**Twickenham Station,
Twickenham**

**Addendum to the Noise and Vibration Chapter
(Chapter 10)**

1.1 This addendum note has been prepared to respond to the London Borough of Richmond upon Thames' EIA Regulation 19 Request, in relation to the proposed development at Twickenham Station.

- LZFmx -

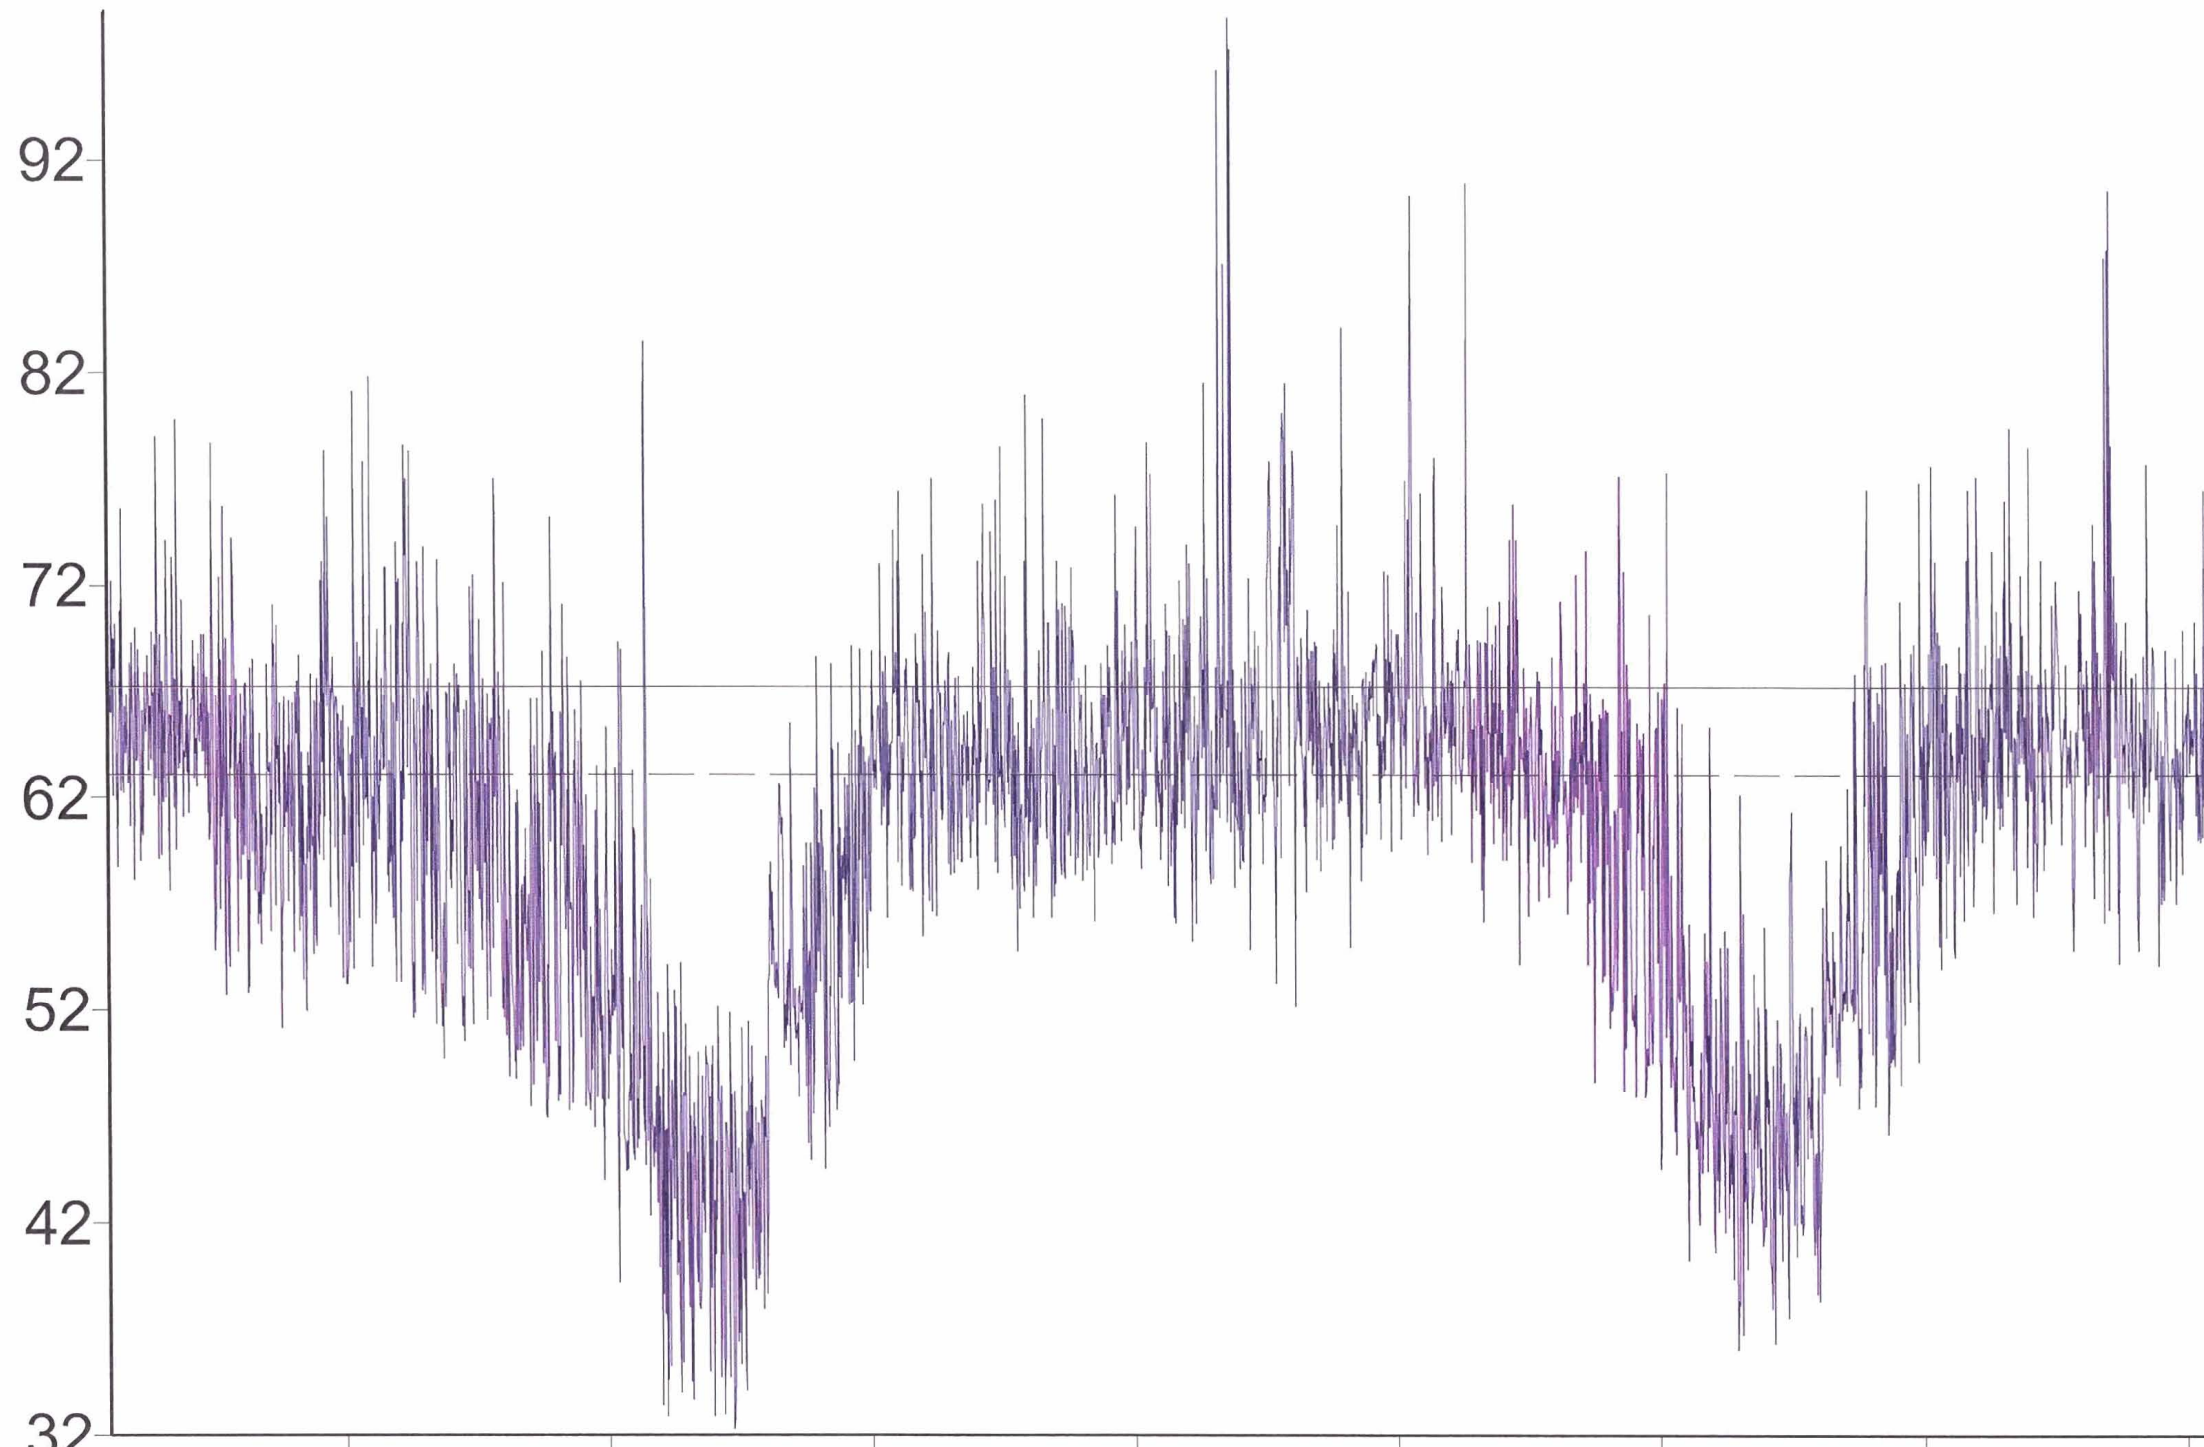
- 2) The PPG24 assessment must also include the nighttimes LMAX levels from train movements and indicate if this a determining factor as (1Night-time noise levels (23.00 - 07.00): sites where individual noise events regularly exceed 82 dB L_{Amax} (S time weighting) several times in any hour should be treated as being in NEC C, regardless of the L_{Aeq,8h} (except where the L_{Aeq,8h} already puts the site in NEC D).

- 6) 10.7.2 Point 4- L_{Max} levels included in order to determine the necessary mitigation.
- 7) A noise model shall be provided which includes horizontal and vertical grid noise contours to demonstrate the affect of transportation noise on new and existing residential receptors with and without the proposed development in place. The London Borough of Richmond upon Thames uses Bruel & Kjaer Predictor noise modelling software, we would ideally want the model in a format that can be imported into predictor.

1.5 From the continuous trace for $L_{(A)MAX}$ it is apparent that there are no regular night-time exceedences of $82 dB_{(A)}$, (where regular night-time exceedence of $82 dB_{(A)}$ would place the location in NEC C, regardless of other result, under the terms of PPG24.).

- 1.28 This is addressed at 1.5 above and the $L_{(A)max}$ trace from the 48 hour monitoring provides the required data for any necessary mitigation measures.

- LZ90.0 -

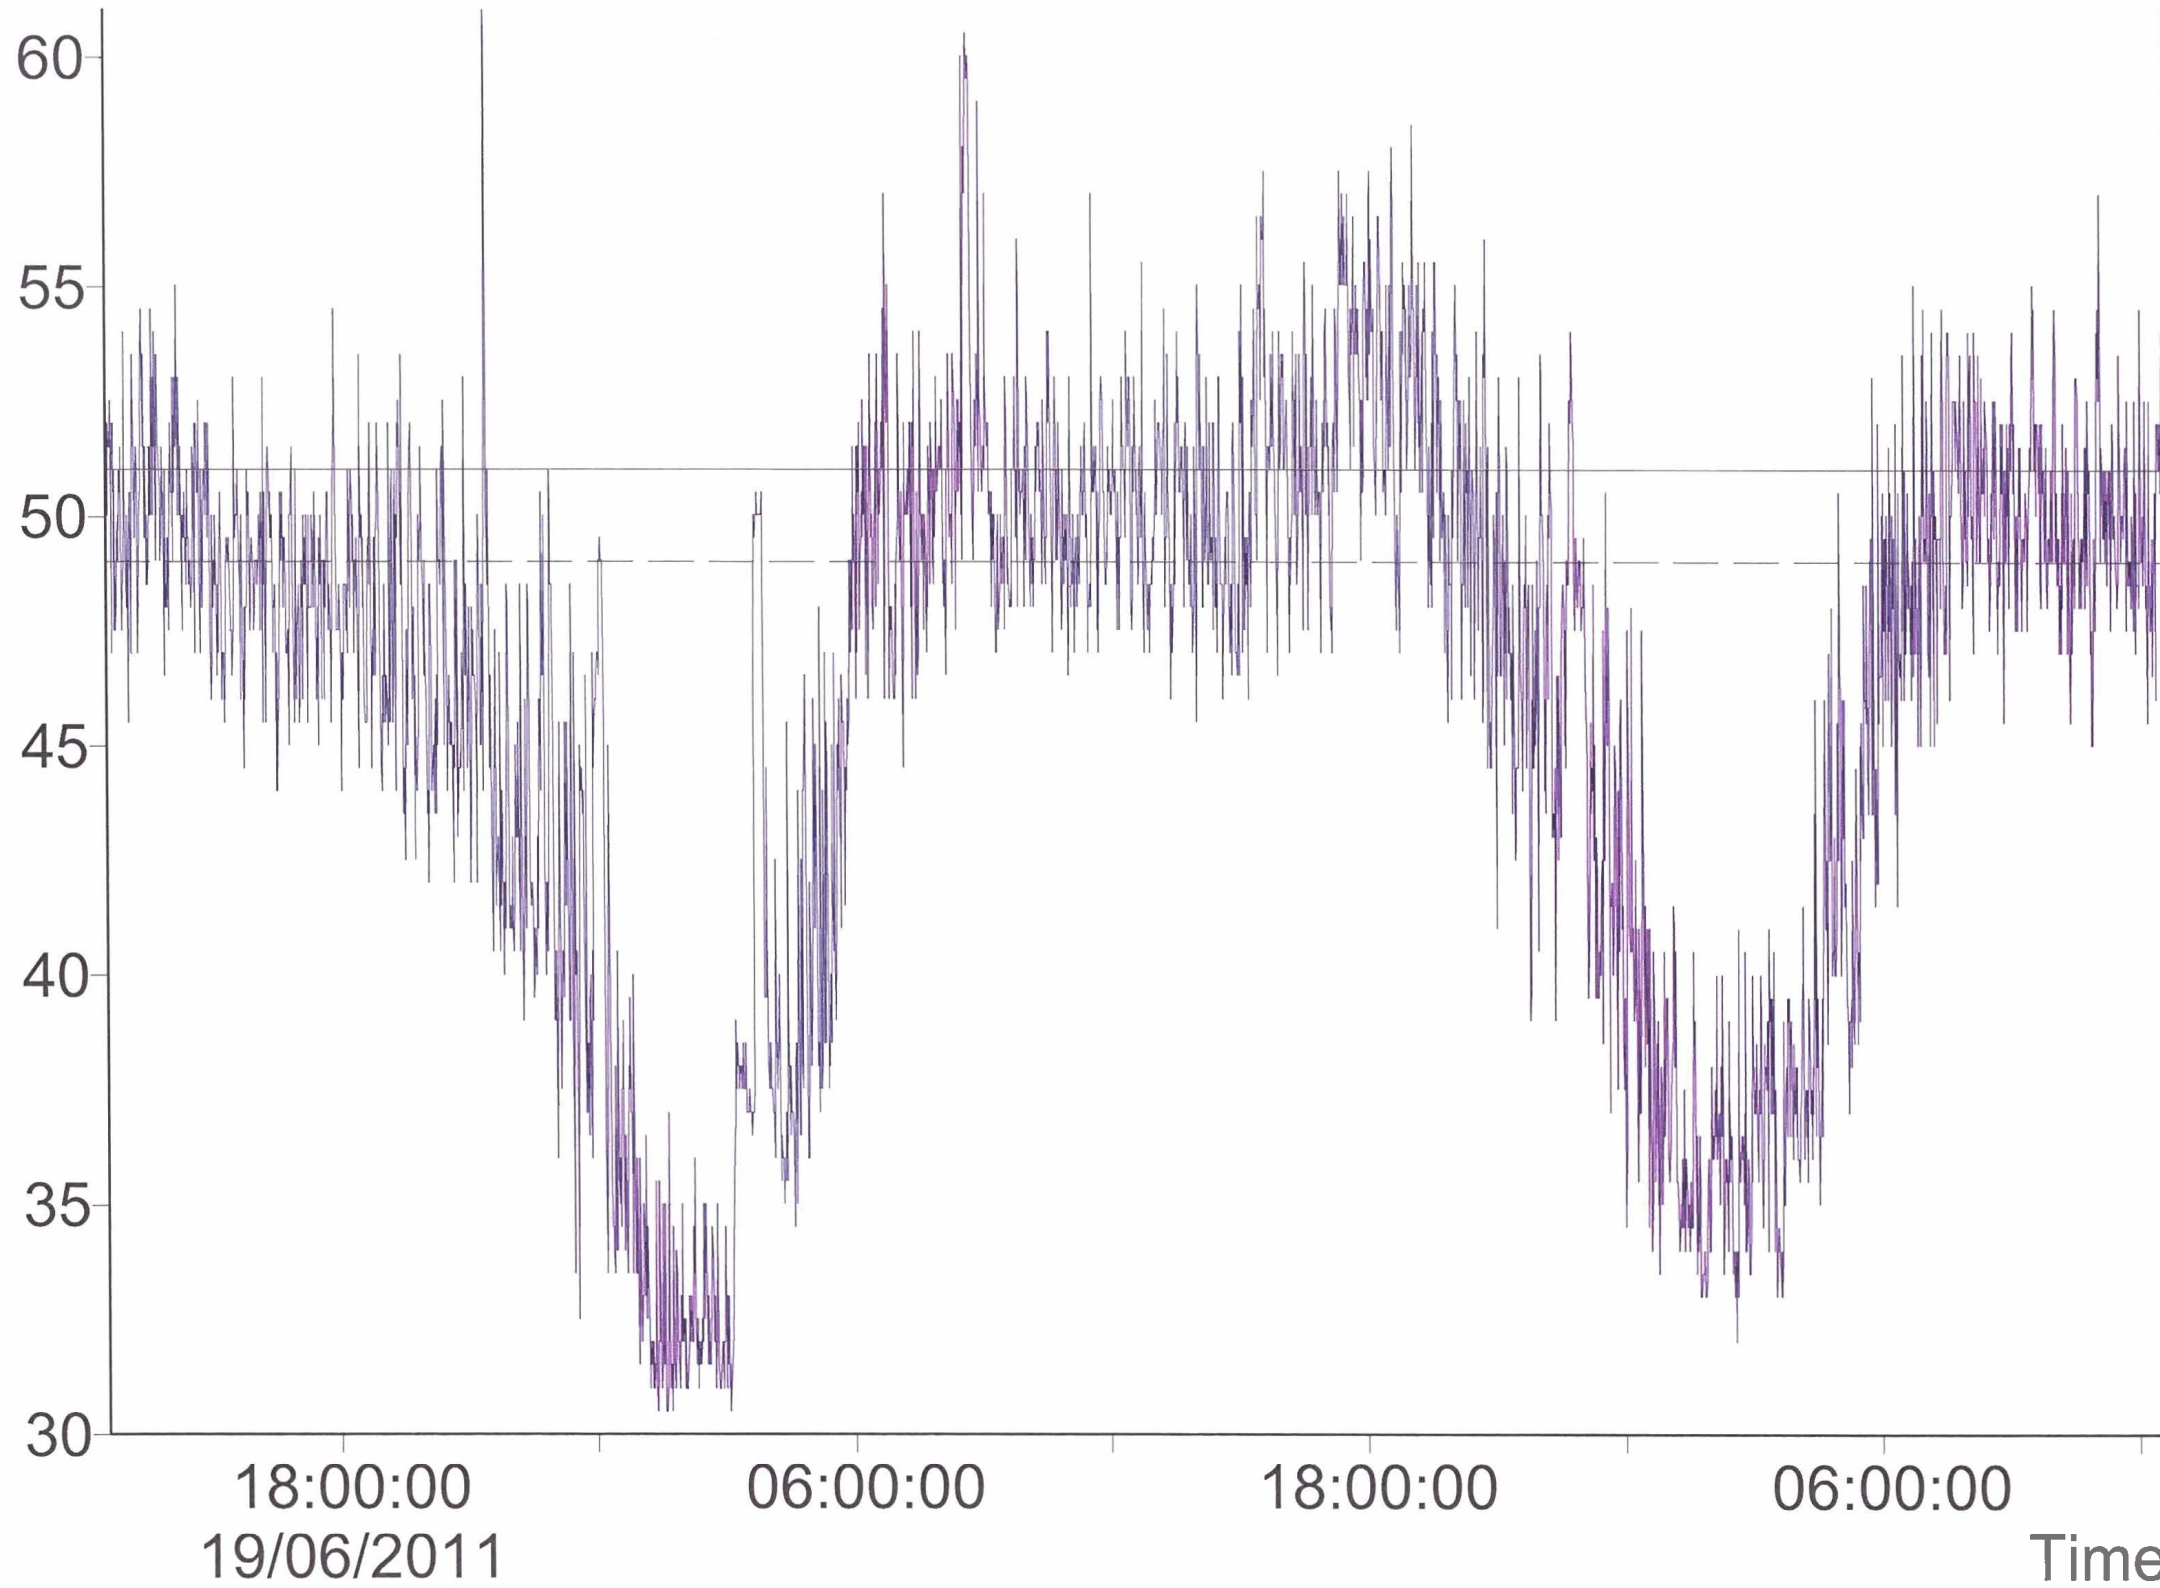
- 3) Mechanical Services- the London Borough of Richmond upon Thames acoustic design criteria for this site is a BS4142 rating level of -5 (-10if any tonal or discreet component) and must also comply with BS8233 good criteria.

- 1.8 From the 48-hour continuous monitoring trace for $L_{(A)90}$, the lowest background noise level would appear occur between late Sunday night and early Monday morning. Further examination of the trace shows a distinct flat-bottomed trough between 01:00 and 03:00 hours on Monday morning, The data for this two hour period was subject to analysis and gave a $L_{(A)90}$ for the period of 36.6 $dB_{(A)}$. The $L_{(A)90}$ calculated from the data for the same period (01:00 – 03:00 hours) on the “weekday” (Tuesday morning) was 40.8 $dB_{(A)}$.

Figure XX Noise Monitoring Locations

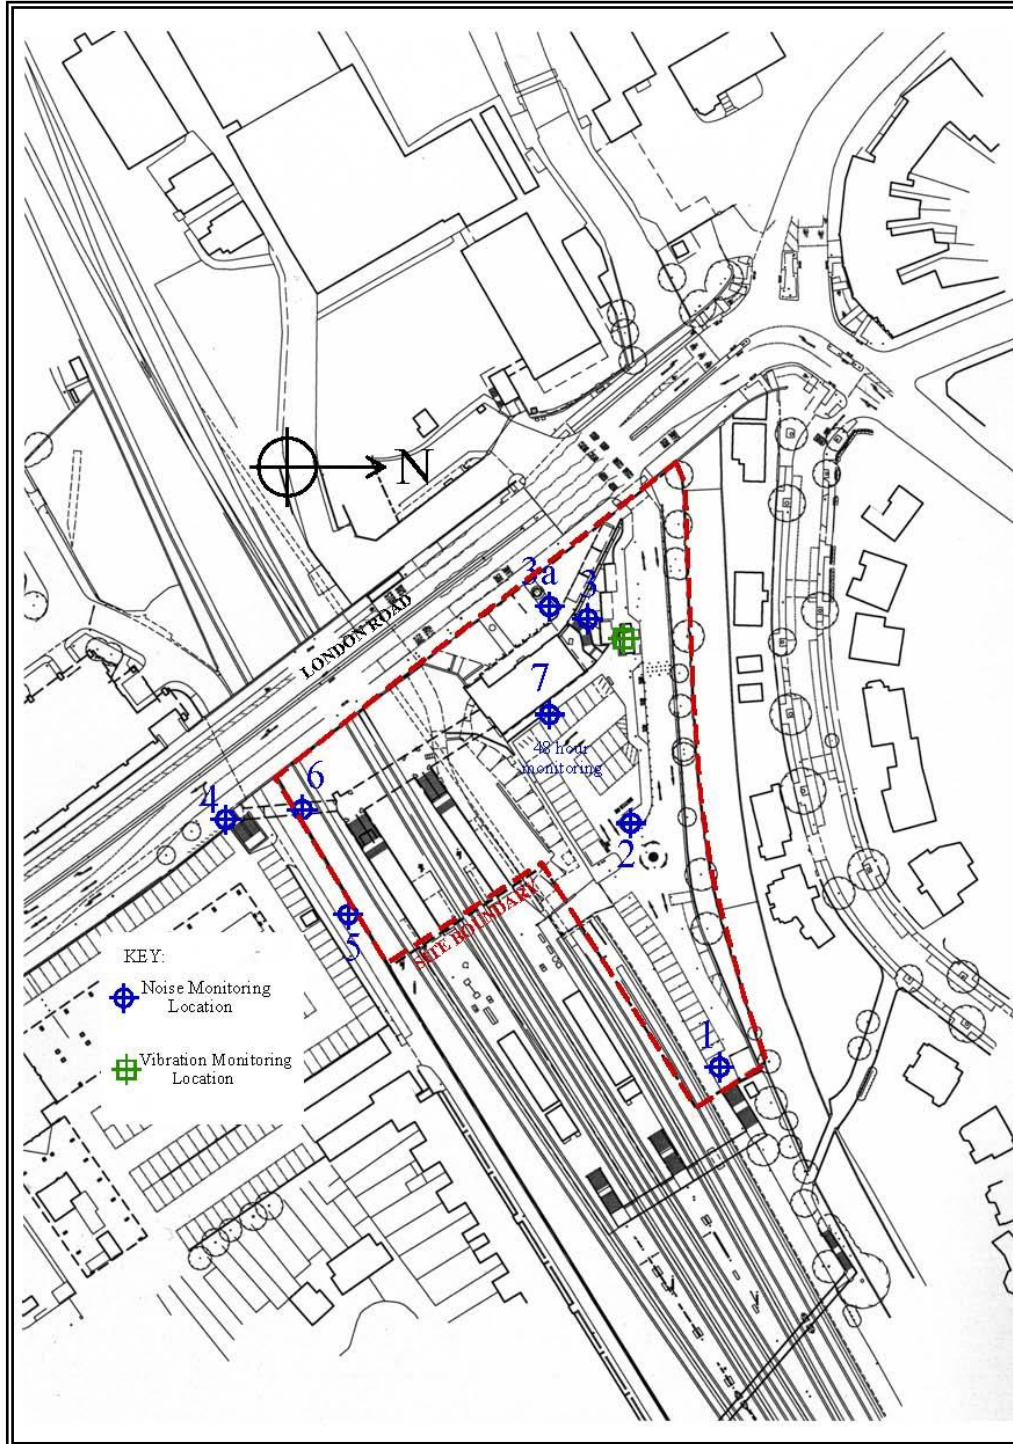
- 1) PPG24 – it is noted from the report that the short method was used to determine the NEC categories. A requirement for longer term measurements are undertaken in order to establish more accurate ambient and background noise data. Therefore we require measurements to undertaken over at least 24-hour period for a weekday, under typical operating conditions of the road and rail network. Also in order to determine the lowest background noise levels in order to determine mechanical services max thresholds measurements should be undertaken over a weekend period to include a Sunday (day, evening and night).

1.4 Continuous 48-hour noise monitoring was carried out at a location overlooking the station car park with a direct line of sight to the railway and at a location reasonably representative of the exposure of the proposed residences within the adjacent area of the existing car park area. The SLM (sound level meter) was secured within the station office mess room with a 2 m microphone boom projecting from the façade at first floor level (Monitoring Location 7; See Fig. XX). Weather conditions at the time of the monitoring were light – moderate south-westerly breezes with occasional rain showers. The results of the 48-hour monitoring are given in the appended traces (See Appendix XX) and are summarised (in terms of PPG24) in Table 1-1 below:
